VILLAGE OF LOMBARD  
REQUEST FOR BOARD OF TRUSTEES ACTION  
For Inclusion on Board Agenda

TO: PRESIDENT AND BOARD OF TRUSTEES  
FROM: David A. Hulseberg, Village Manager  
DATE: May 25, 2011 (BOT) Date: June 2, 2011  
TITLE: PC 11-12: 500 E. Roosevelt Road  
SUBMITTED BY: Department of Community Development *MJ*

**SUBJECT:** PC 11-12; 500 E Roosevelt Road

**VILLAGE OF LOMBARD**  
INTER-DEPARTMENTAL REVIEW GROUP REPORT (revised 5/16/11)

**1 (WEST) ELEVATION**  
SCALE: 1/8" = 1'-0"

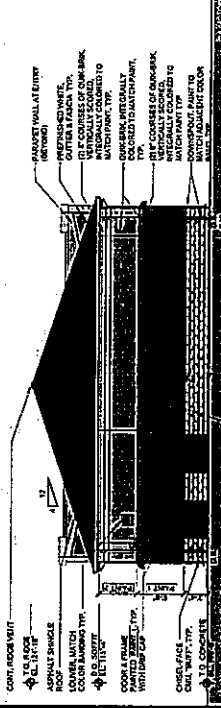
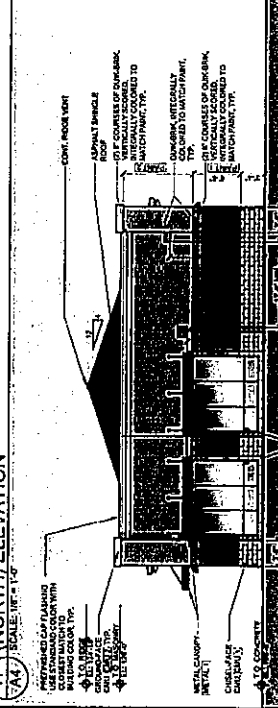
Commissioner Olbrysh questioned the east side of the building and was concerned about the appearance. Mr. Whitaker stated that the picture does not accurately reflect how this site will look. They are providing additional landscaping to break up the mass of the building.

16. The elevations shall be revised to substantially conform to the color, materials and architectural design elements depicted in the photographs submitted by the petitioner and attached as Exhibit C.
